ADDENDUM #2

NORTH TRUCKEE DRAIN REALIGNMENT PHASE 1

BID #13/14-007 – PWP# WA-2014-011

This addendum is to notify all potential proposers of clarifications made to the Bid documents as stated below.

DESIGNED BY: PEO	CHECKED BY: NL	APPROVED BY: NL	SCALE: 1"=40'	HORIZ: N/A	VERT: N/A	REV No	DATE
						DESCRIPTION	APPROVED
NORTH TRUCKEE DRAIN REALIGNMENT PHASE 1 GRADING PLAN "NTD" STA 52+50 TO STA 61+00 "G" STA 9+50 TO STA 20+00							
SHEET NO. C-9							
SHT OF							
ADDENDUM 2 11/14/13

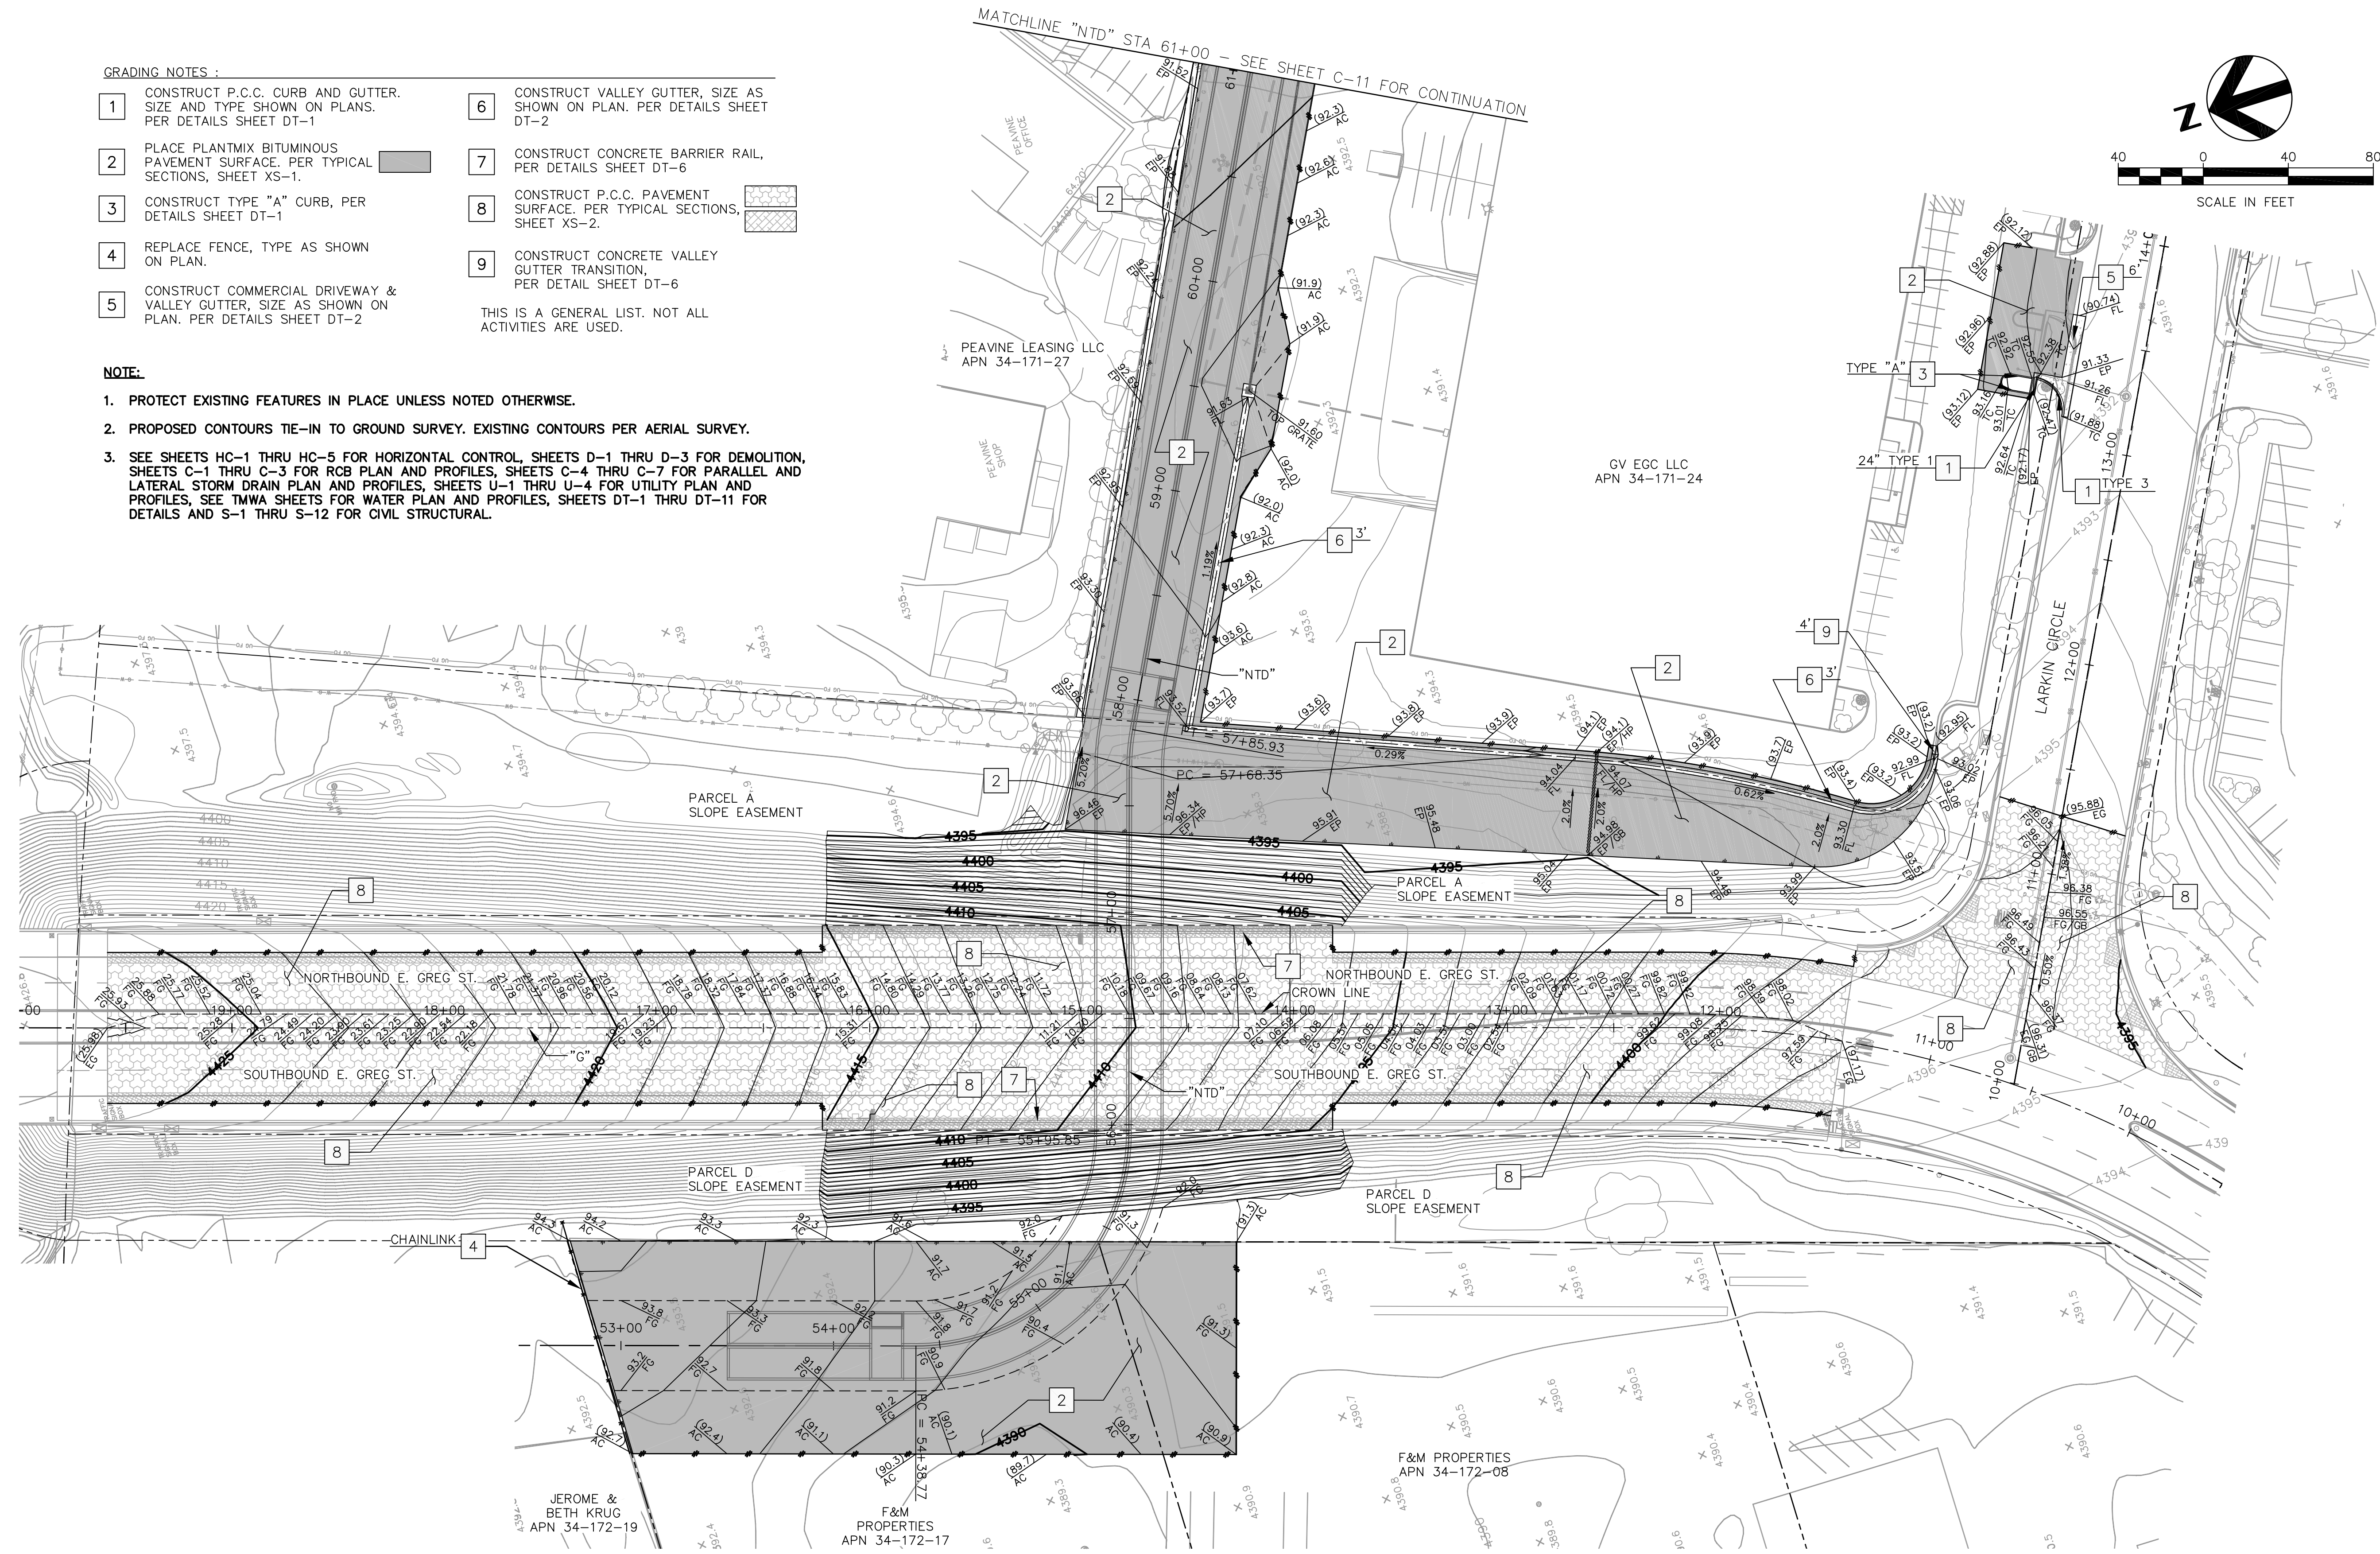
7. Sheet C-9 – All notes, contours, elevation callouts and hatching limits for the PCC paving on Greg Street, including the intersection with Larkin Circle, were changed.

SHEET No **C-10**
 SHT OF

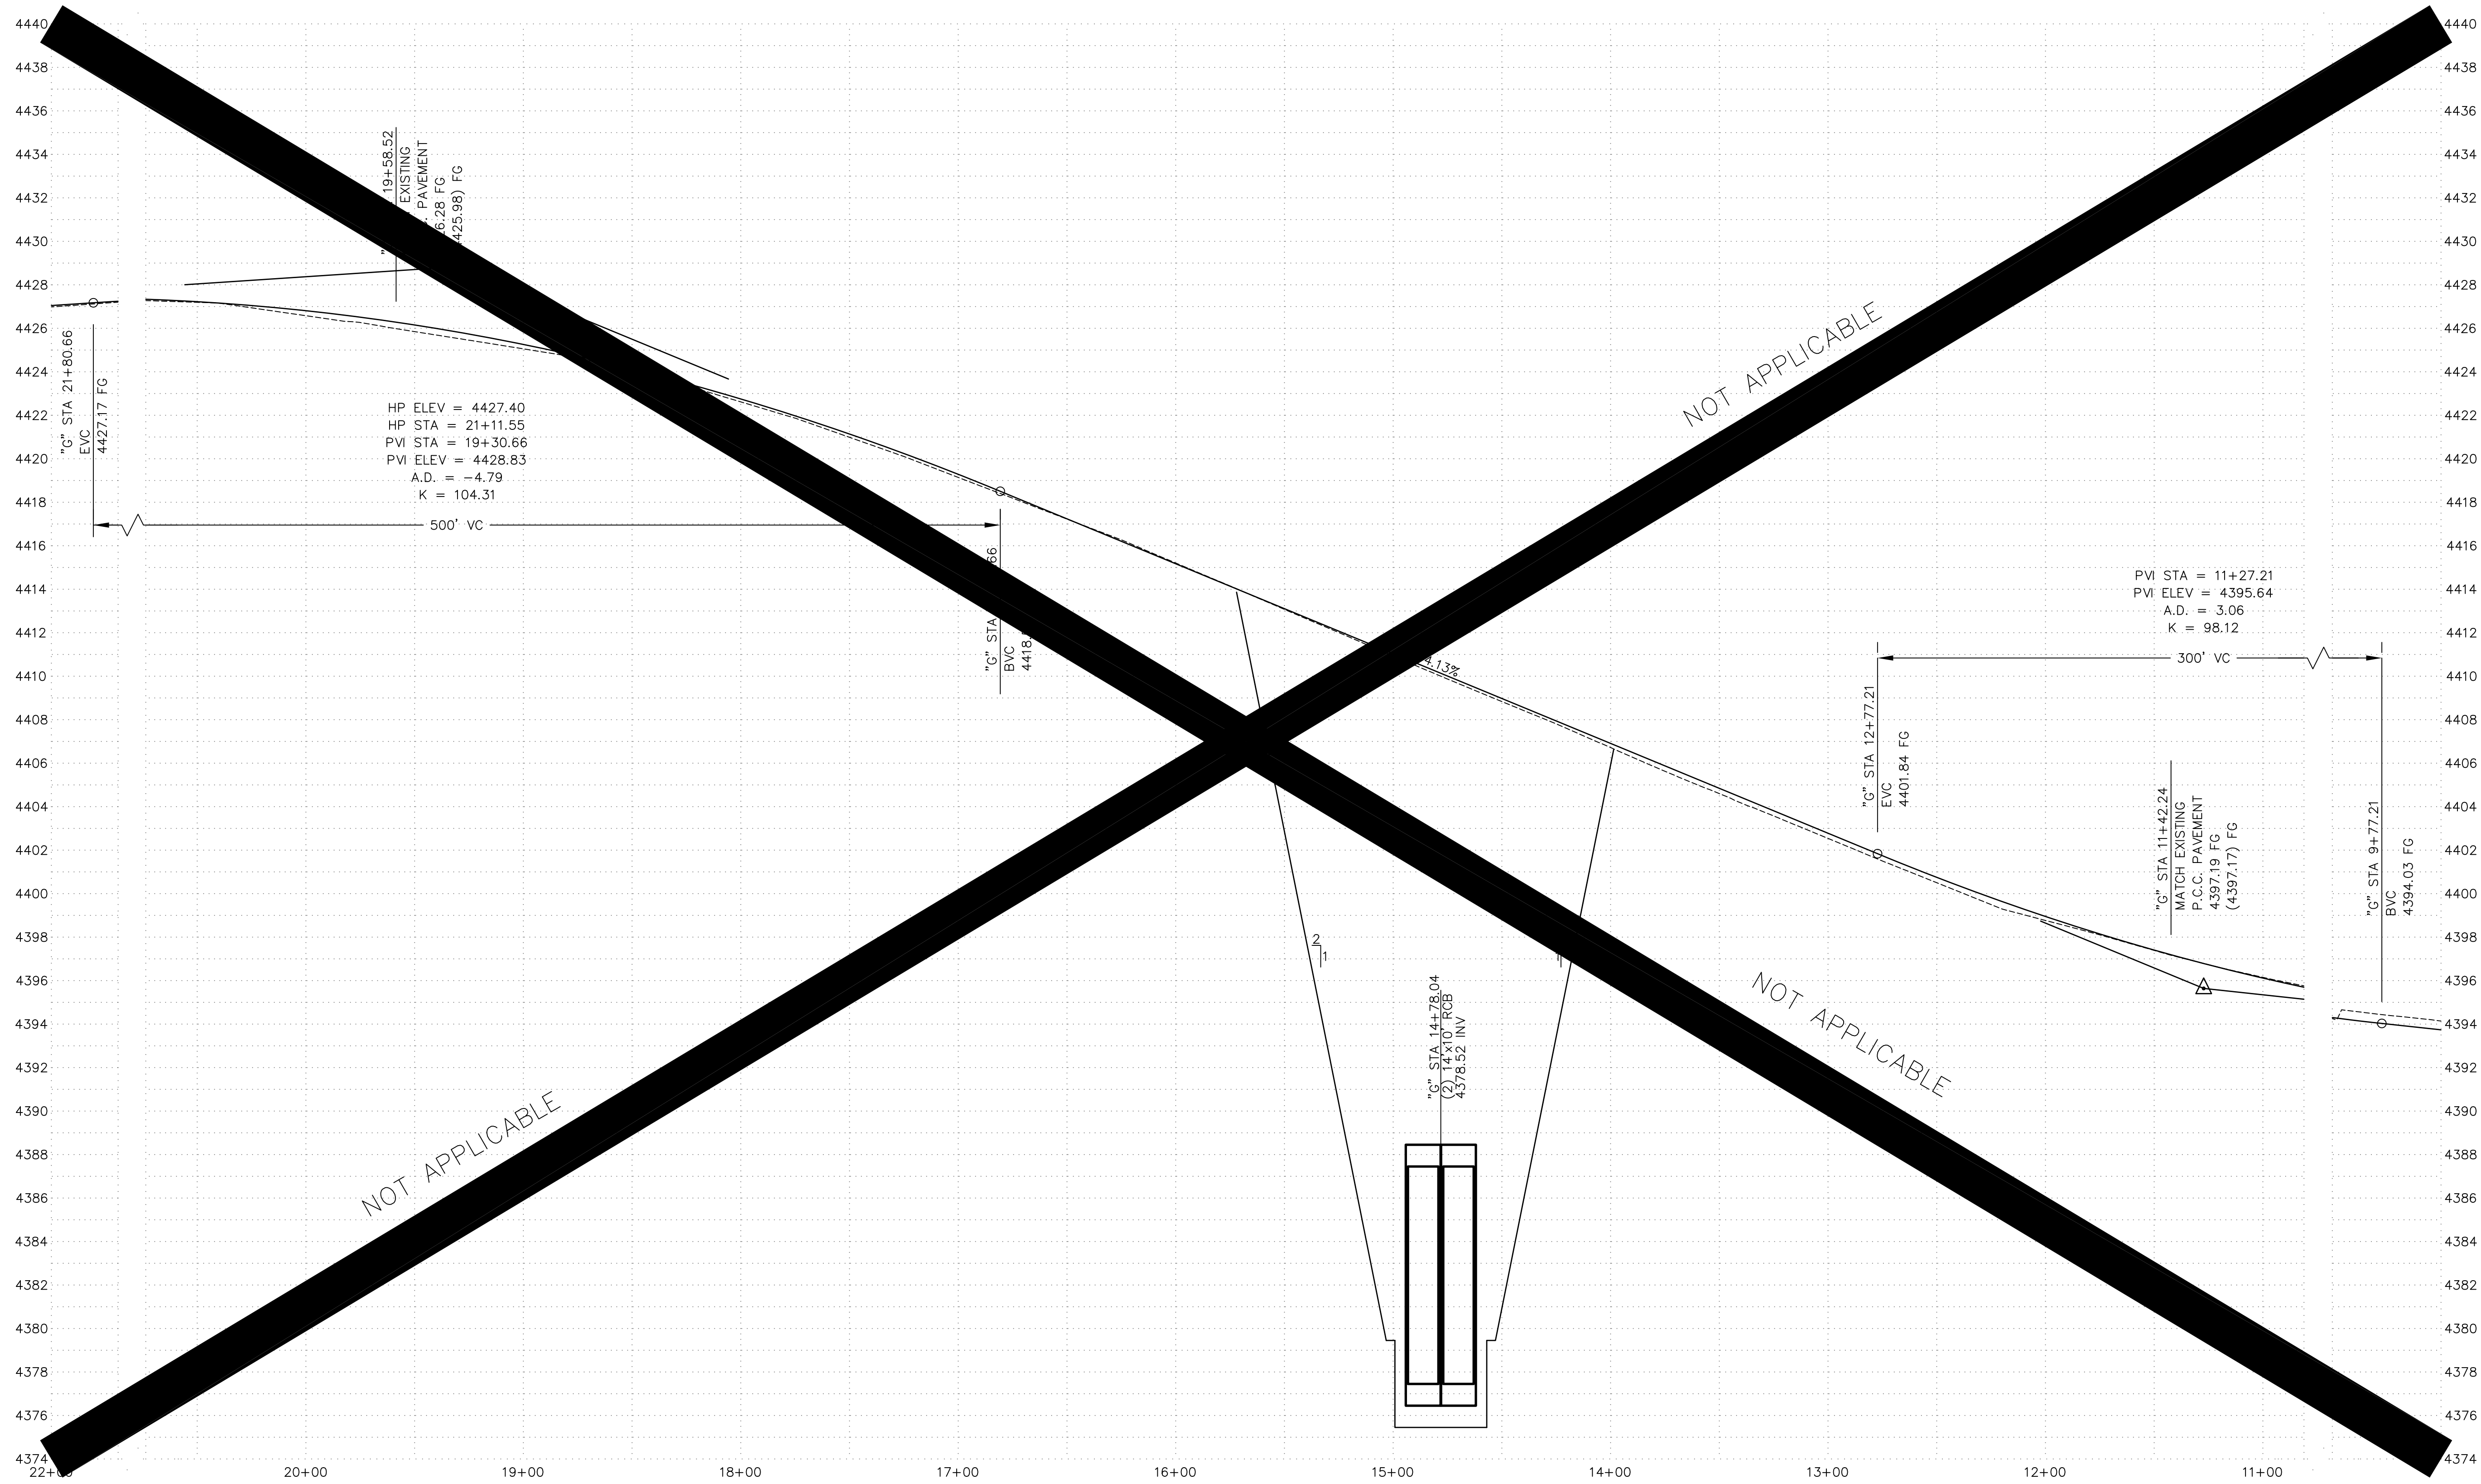
8. Sheet C-10 – Sheet is no longer applicable
9. Sheet C-12 – Sheet was changed in its entirety.
10. Sheet C-13 – Sheet was changed in its entirety.
11. Sheet C-14 – Sheet was changed in its entirety.

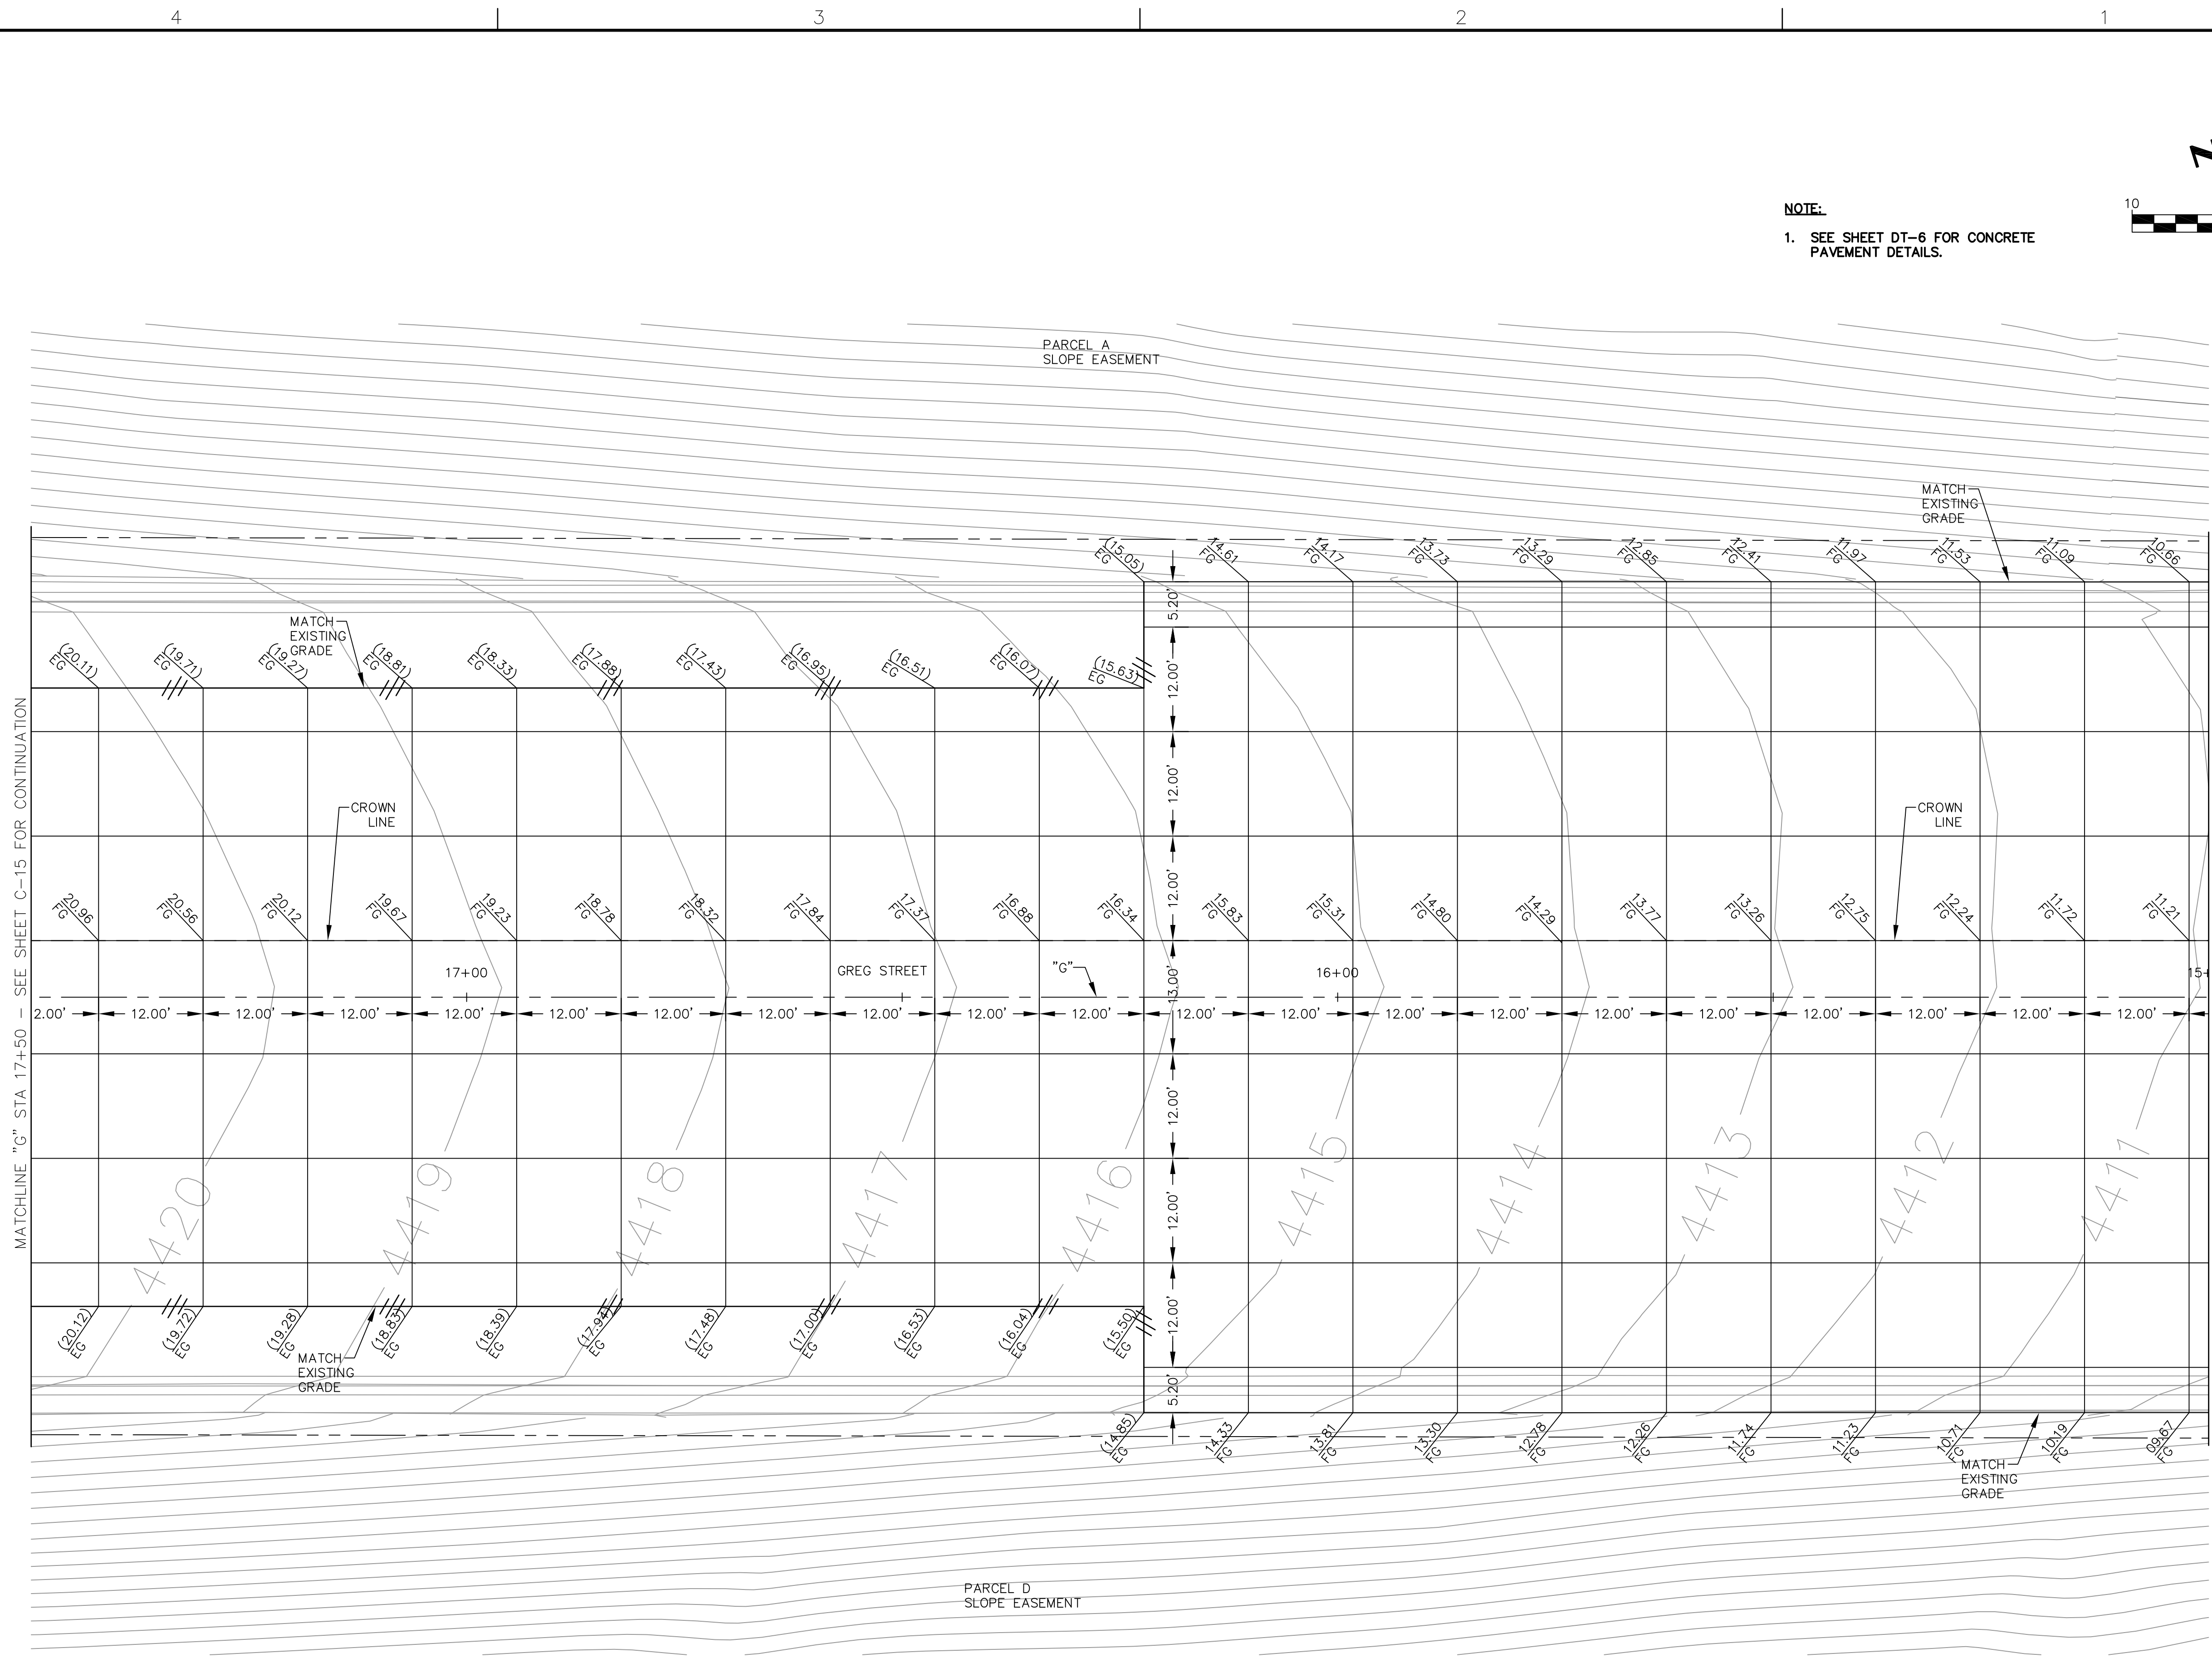
12. Sheet C-15 – Sheet was changed in its entirety.
13. Sheet ST-1 –
 - a. Notes and dimensions were changed throughout the sheet.
 - b. Note 11 was added.
